June 24, 2024

To: Plan Holders for Improvements to the
KIRKSVILLE REGIONAL AIRPORT
KIRKSVILLE, MISSOURI
MODOT PROJECT NO. 24-028A-1

**ADDENDUM NO. 5
TO
CONTRACT DOCUMENTS, SPECIFICATIONS AND PLANS
FOR IMPROVEMENTS TO THE
KIRKSVILLE REGIONAL AIRPORT
KIRKSVILLE, MISSOURI
MODOT PROJECT NO. 24-028A-1**

5 LIGHT POLE CONCRETE BASE DETAIL
N.T.S

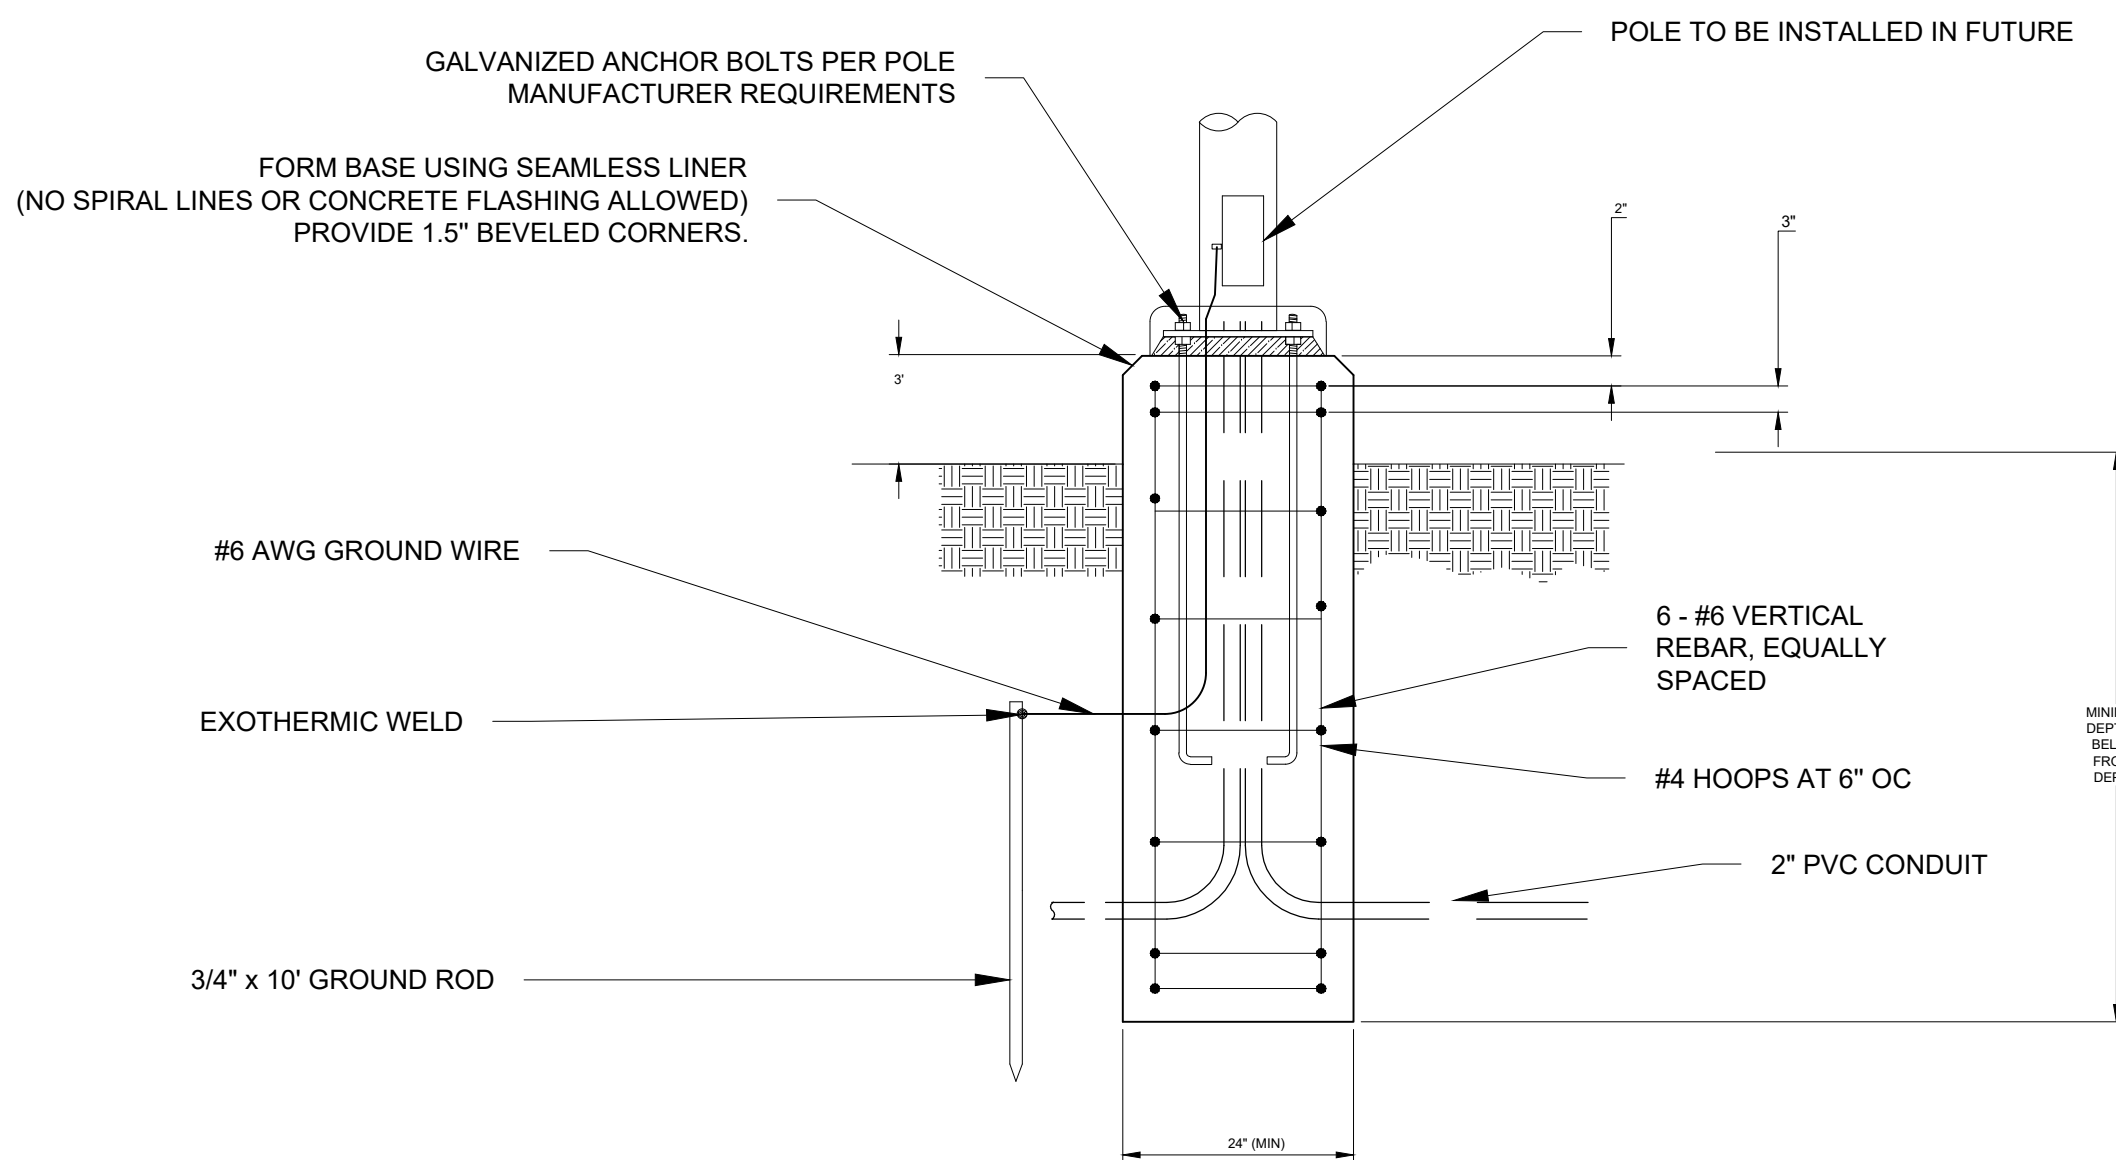
Sheet No.: CE200

Title: ELECTRICAL DETAILS

Revision: Updated fixture schedule and pole heights. Update the controls for the apron and parking lot lights to have a digital timeclock control.

CE201

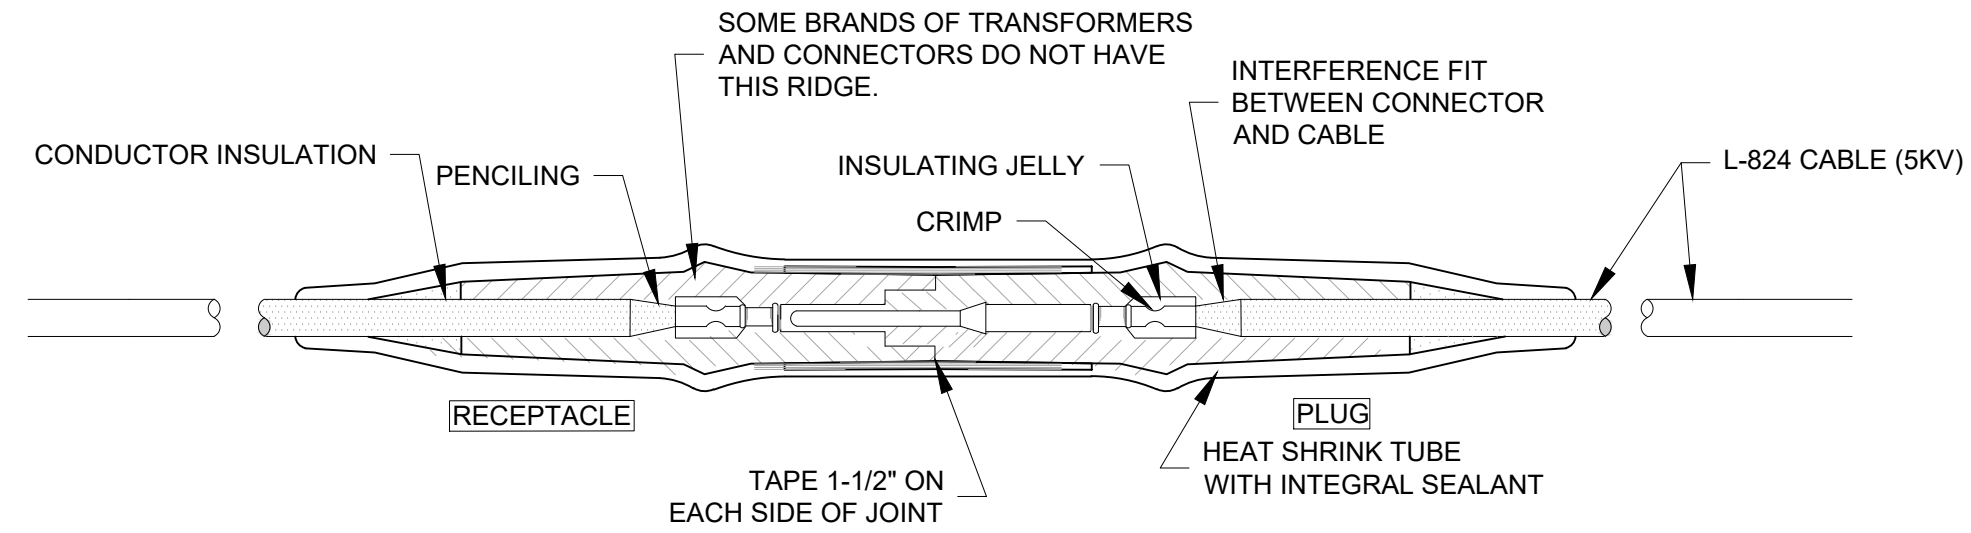
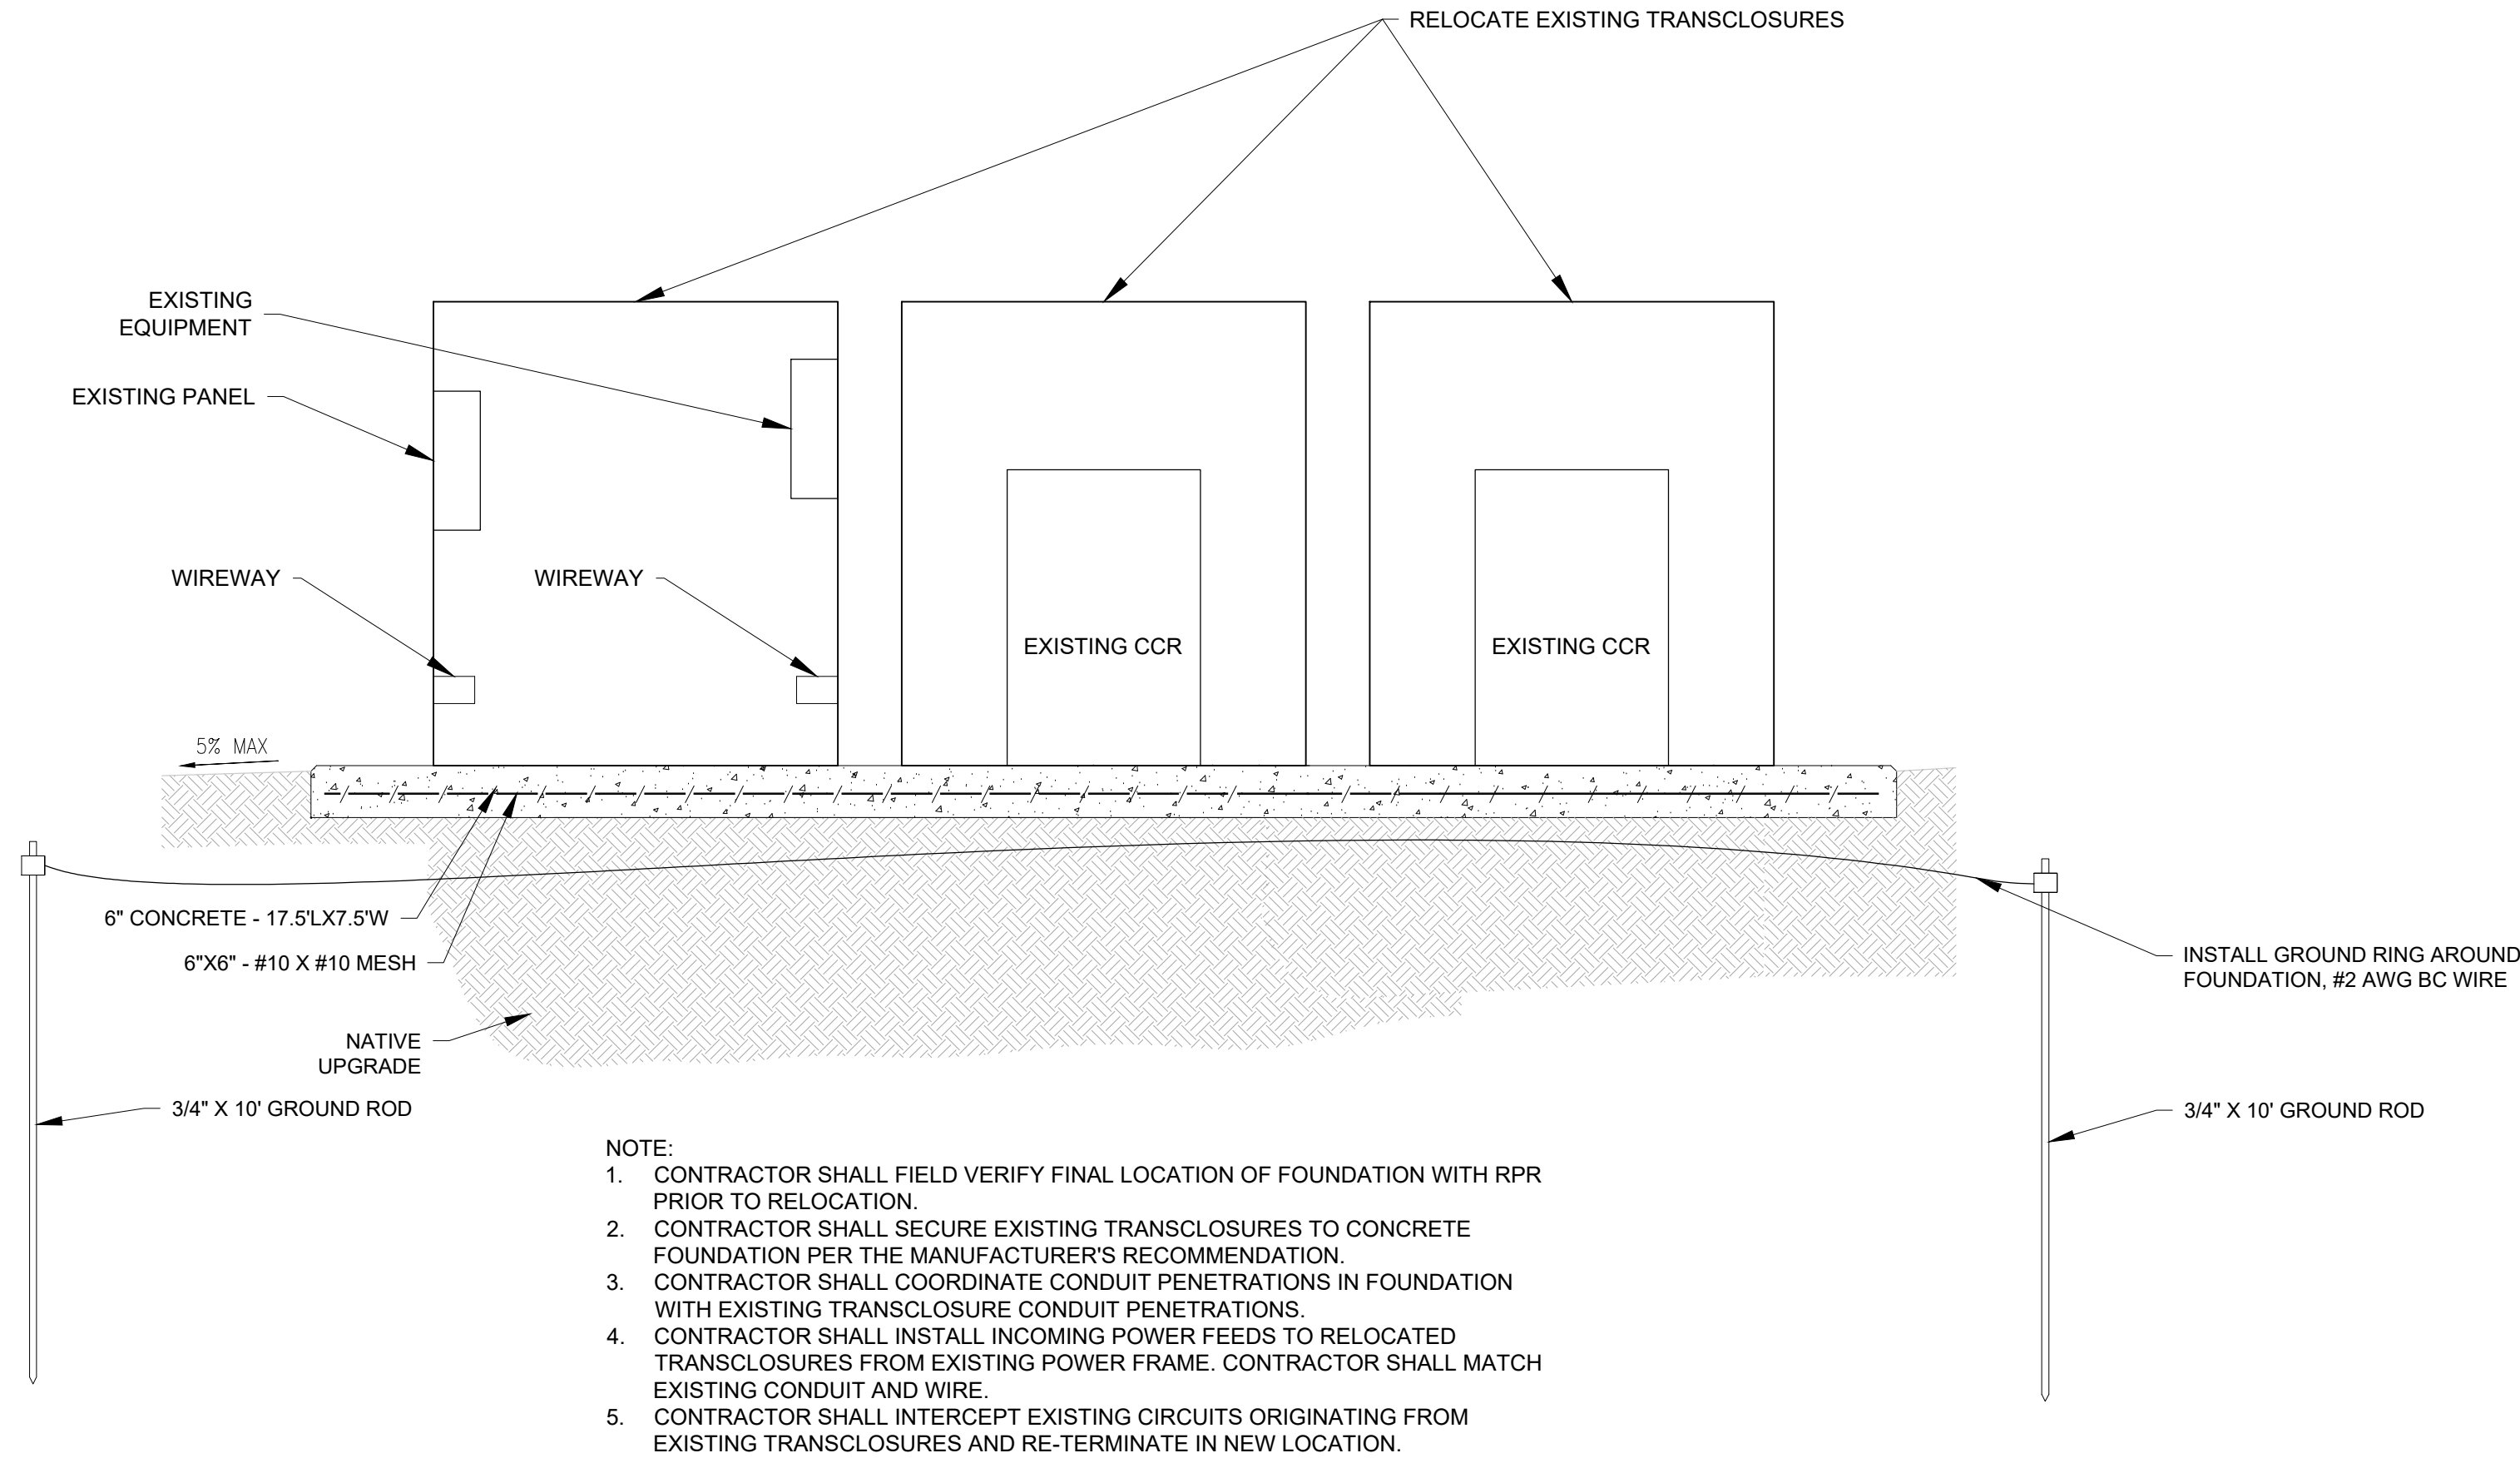
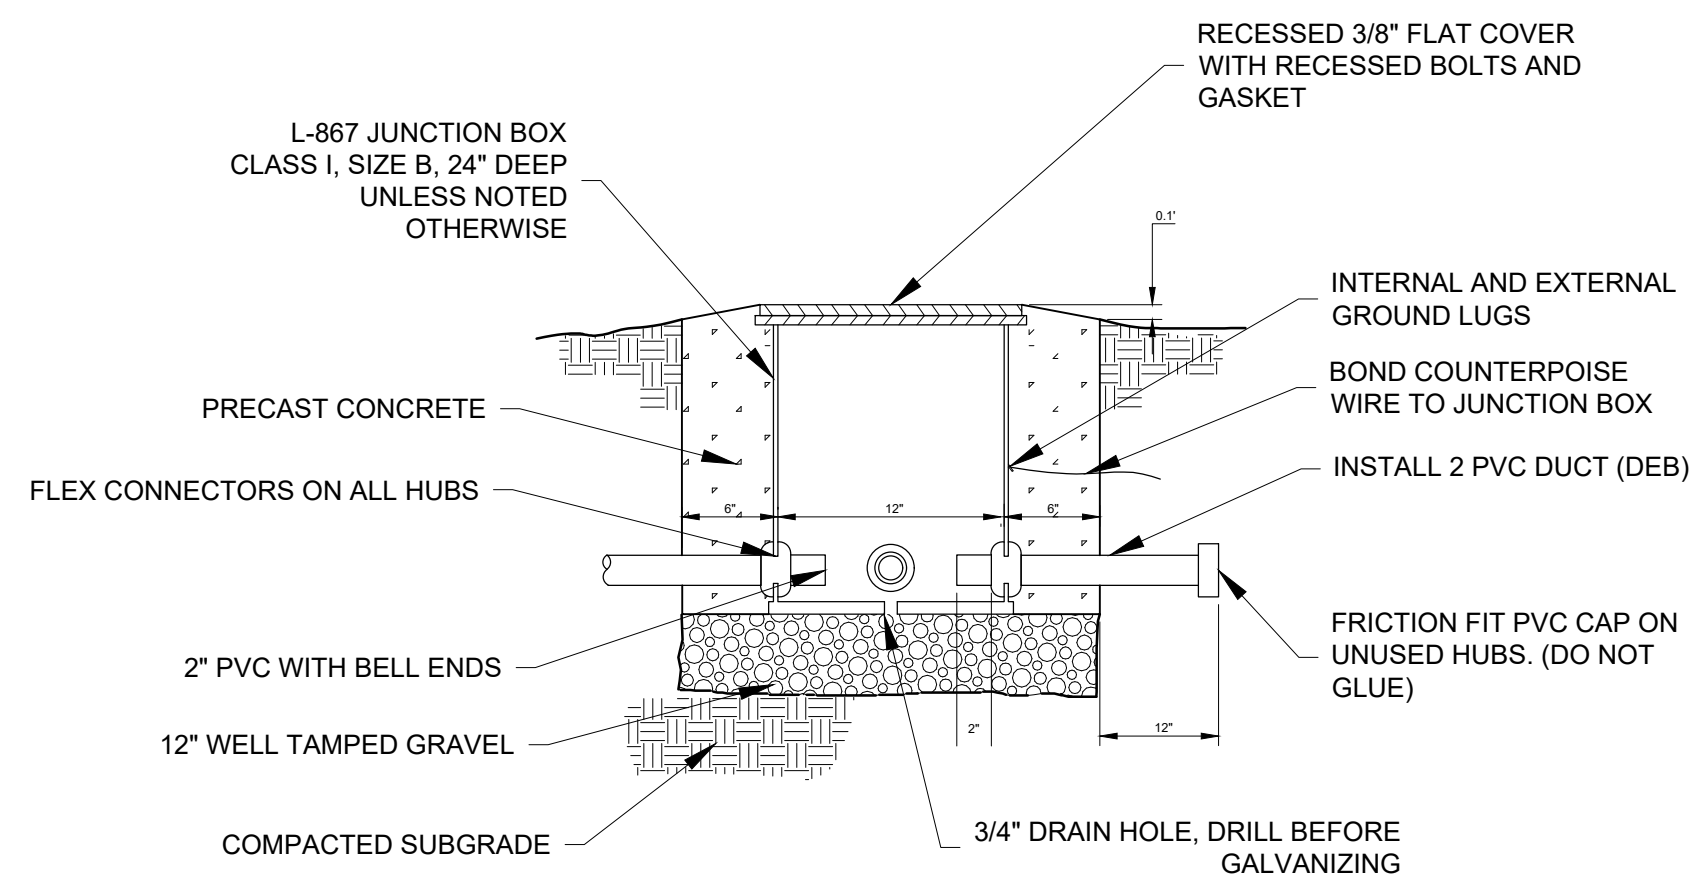
Sheet No.: CE201

Title: ELECTRICAL DETAILS

Revision: Added new sheet in its entirety. Added a detail for the transclosure relocation. Added airfield lighting cable primary connector installation detail. Added a junction box detail.
